**STAFF REPORT**  
**CITY OF BEVERLY HILLS**

**For the Design Review Commission  
Meeting of March 3, 2011**

**SUBJECT:** Required revisions to a previously approved R-1 Design Review Permit to allow a new two-story single-family residence located in the Central Area of the City, north of Santa Monica Boulevard at **804 North Camden Drive**. (PL 090 5850)

Revised Elevation

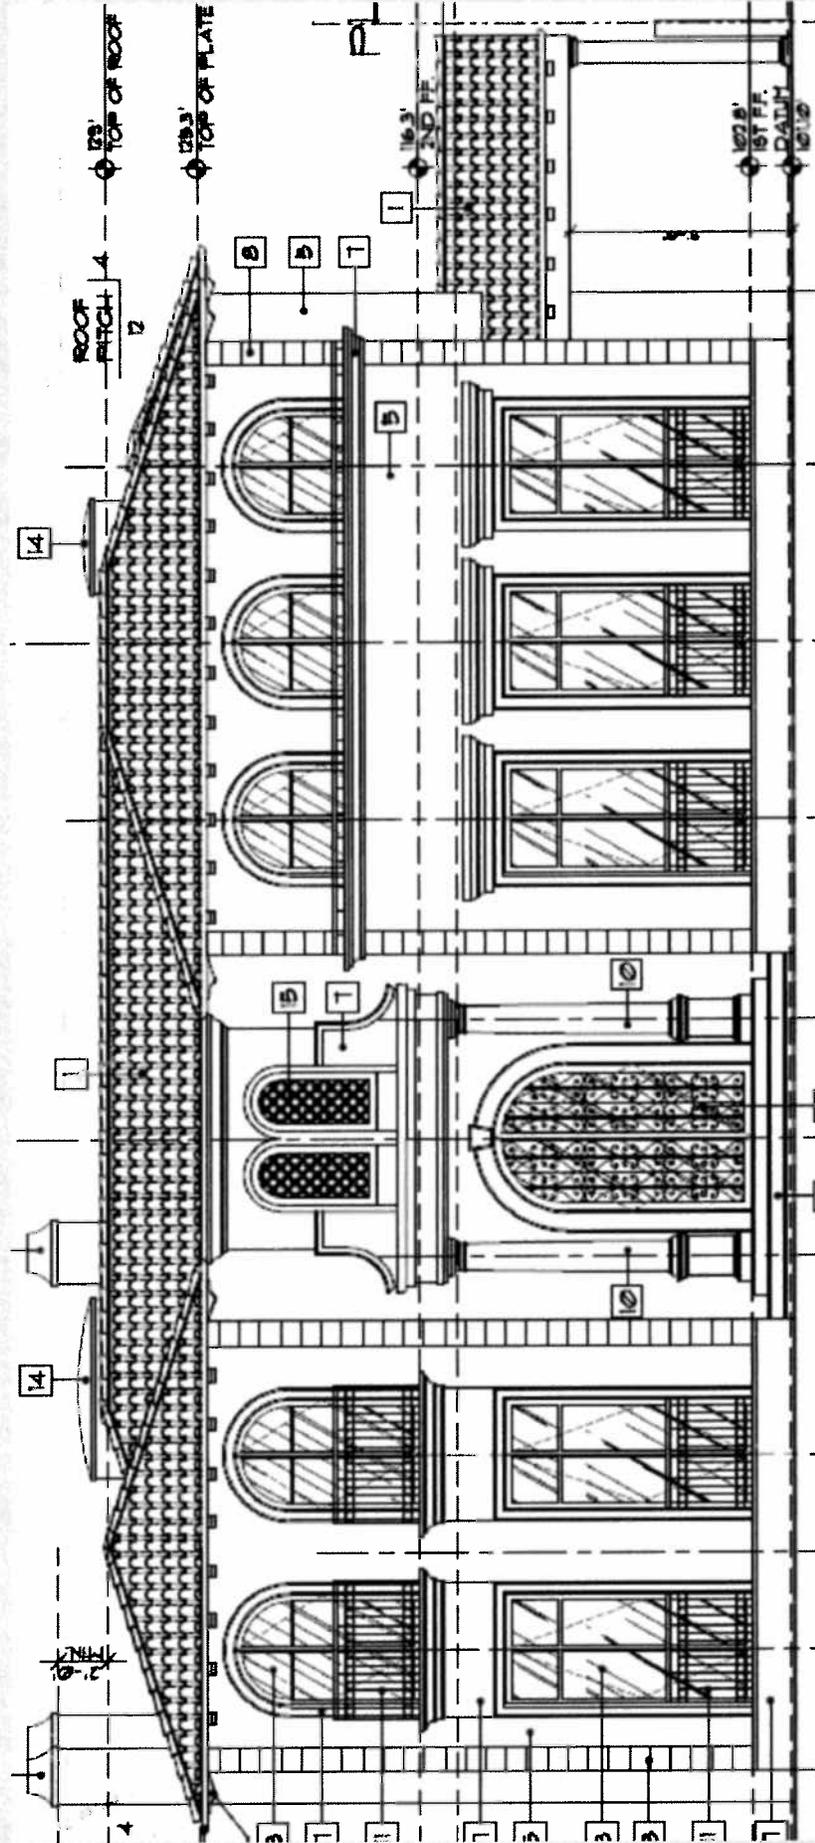
<b>Design Review Commission Requests at the March 5, 2009 Meeting</b>	<b>Applicant's Response</b>
1. A detail of the proposed stained glass windows above the entry be provided (textured only; no flowers, fruit, etc.)	1. The applicant has provided a picture of the windows placed above the entry, which contain clear glass.

2. A detail of the wrought iron railing along the front façade be provided.	2. The applicant has provided a picture of the wrought iron railings installed along the façade. (See picture A. on page of the picture pages.)

5. The pediments be removed from above the first floor French Doors.	5. The applicant is requesting to maintain the pediments above the first floor French Doors.

6. The first floor French be reduced to a maximum of 10' in height.	6. The applicant has reduced the height of the French doors from 10'-6" to 10'-0".
7. The skylights be reduced in height to be within the maximum height allowed for the structure (28').	7. The skylights have been reduced to meet the maximum height requirements.

In addition to the changes listed above, the applicant is also requesting the approval of the altered second story balcony along the right half of the front façade. The approved design contained a solid stucco balcony barrier. As revised, the balcony now contains sections of wrought iron.

Revised North Elevation w/ fence

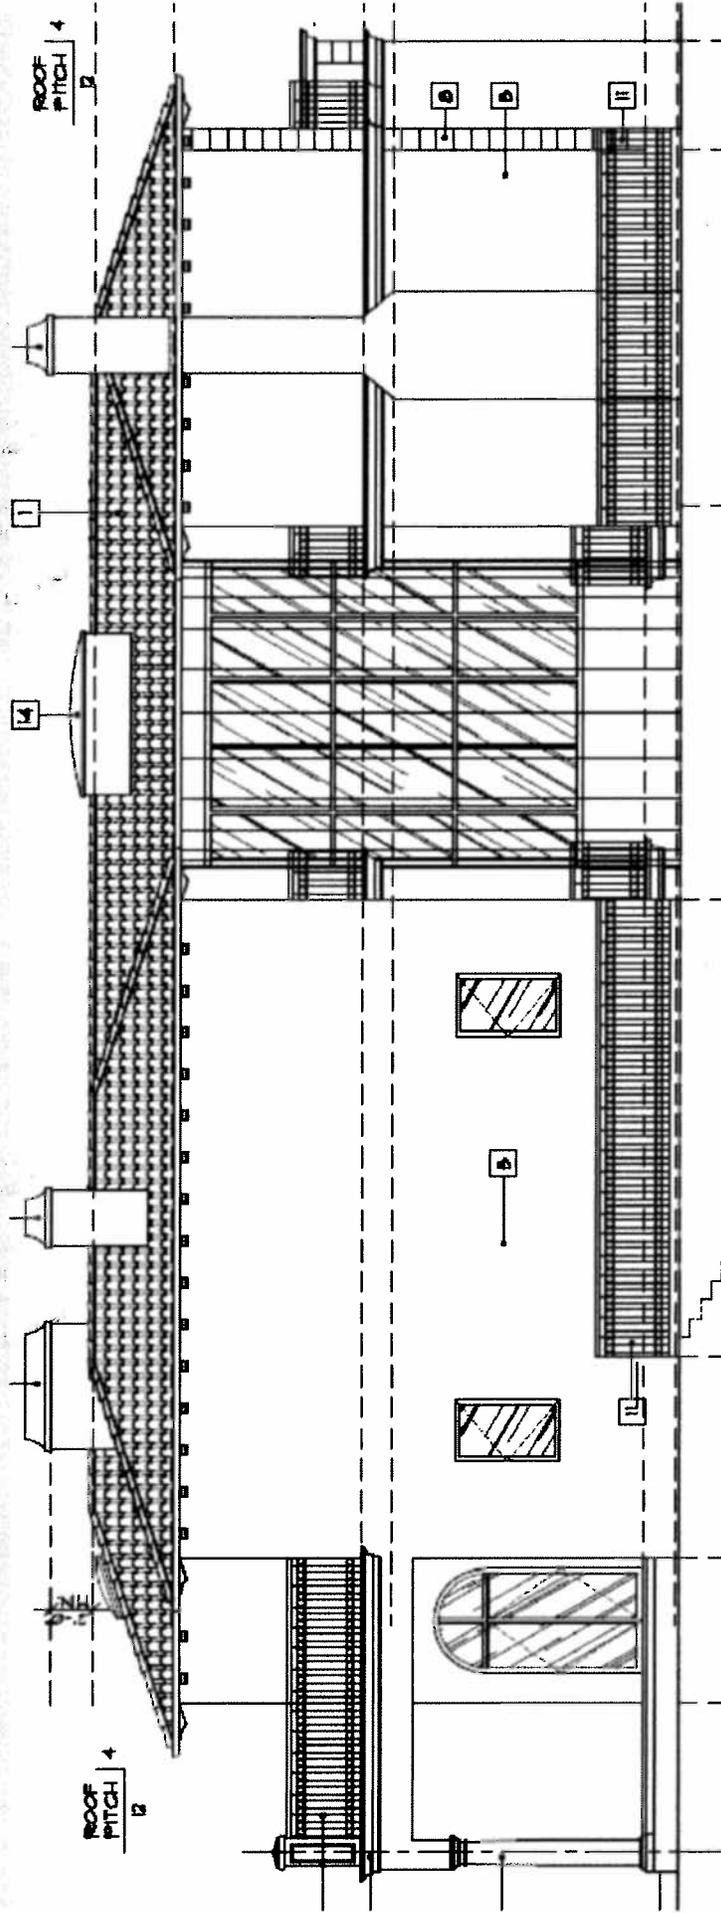
8. The balconies along the north elevation (in the recessed portion of the façade) be redesigned as Juliette balconies.	8. The balconies have been revised to Juliette balconies.

10. A large tree (minimum 48" box) be planted by the recessed portion of the northern elevation to screen the wall of windows adjacent to the internal staircase from the neighboring property.	10. The applicant has consulted with the neighboring property owner to the north and a resolution was reached to alternatively plant a row of ficus trees (36" boxes) along the northern property line. The applicant will be providing pictures of these trees at the meeting on March 3, 2011.

Revised South Elevation w/ fence

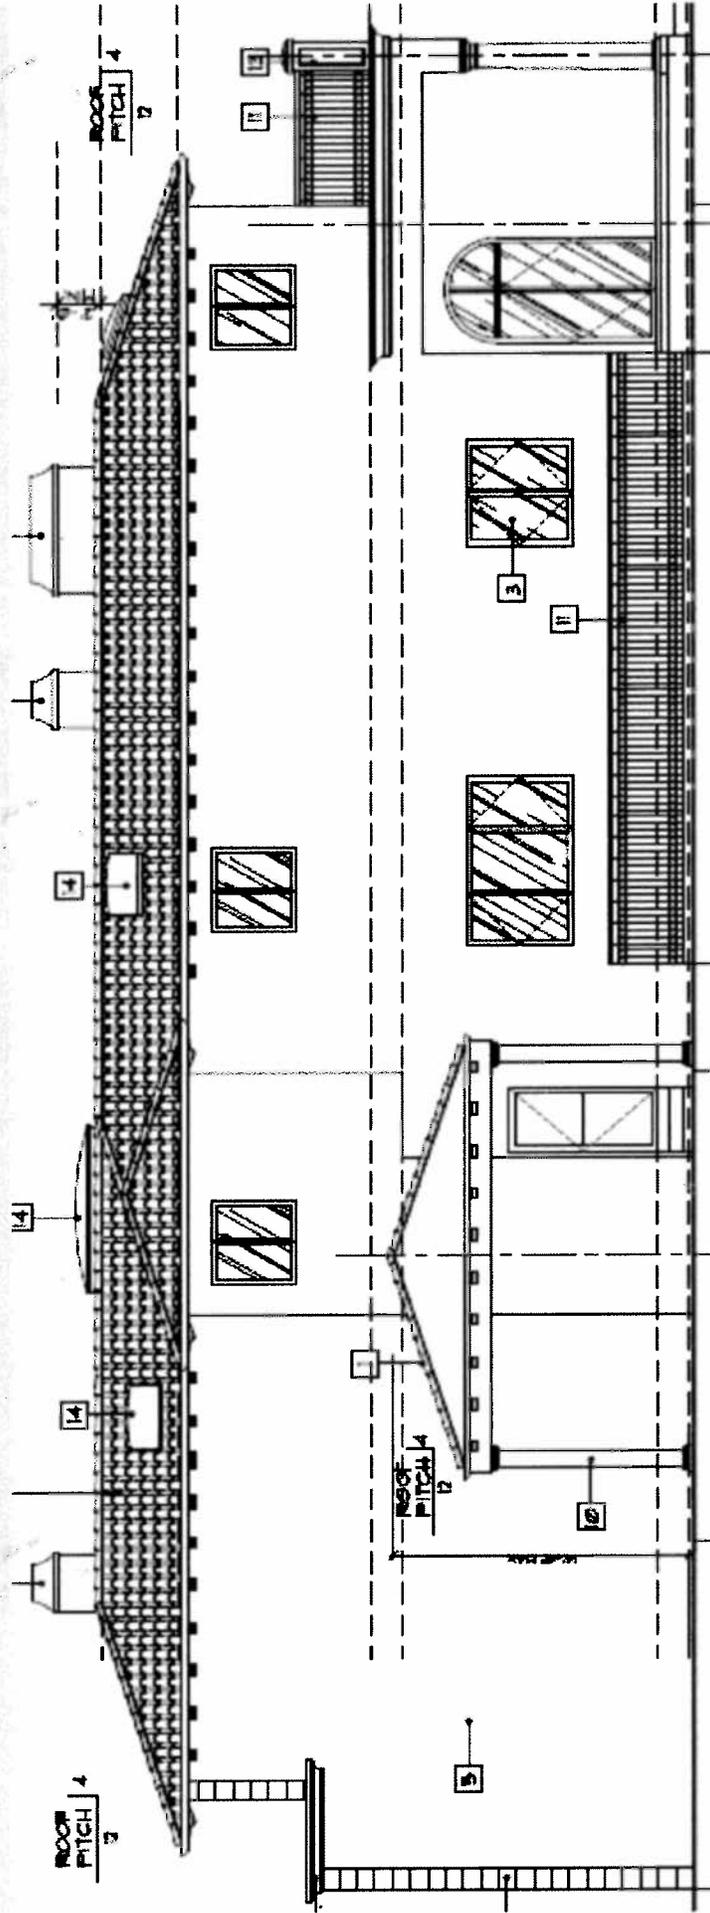
12. The carport along the southern elevation shall be redesigned to meet the definition of carport pursuant to Beverly Hills Municipal Code §10-3-100.	12. The applicant has revised the carport, which now meets the requirements for carports that are established in the Beverly Hills Municipal Code.

Revised Rear Elevation

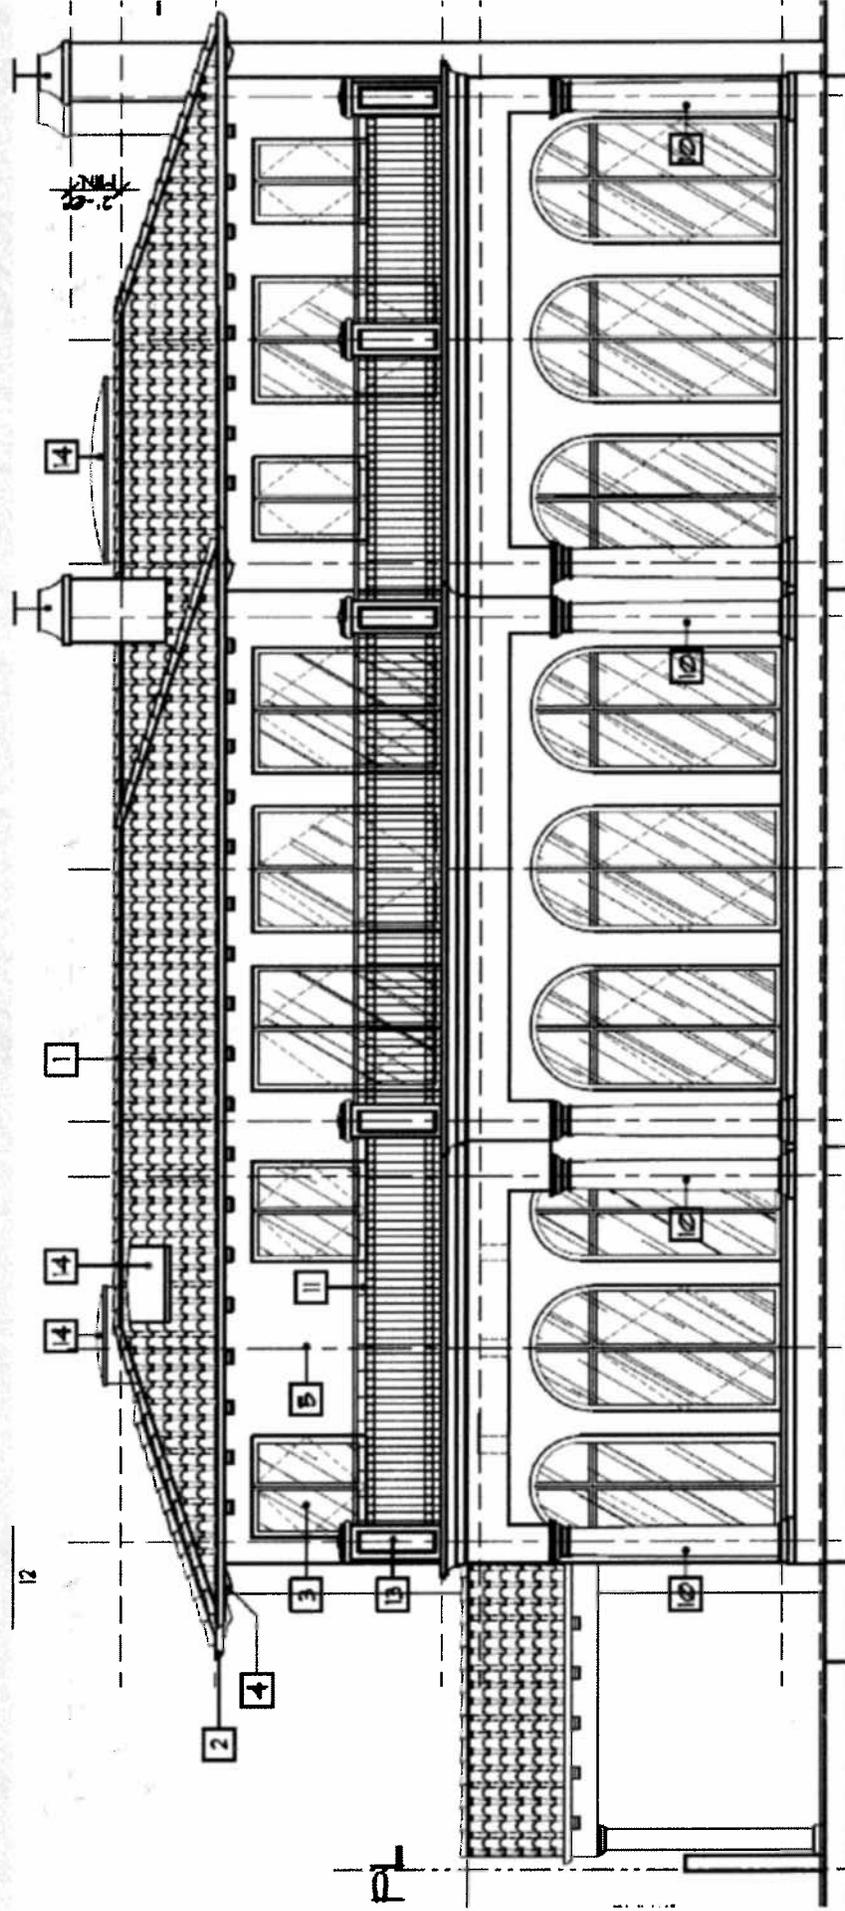
9. A trellis be added to the northern portion of the deck/balcony at the rear of the residence to provide further screening and privacy for the neighboring residence.	9. The applicant is requesting not to provide the trellis. The applicant has provided pictures to demonstrate that the existing hedges fully screen the neighboring residence from the balcony. (See the pictures titled "Rear balcony pictures" in the packet)
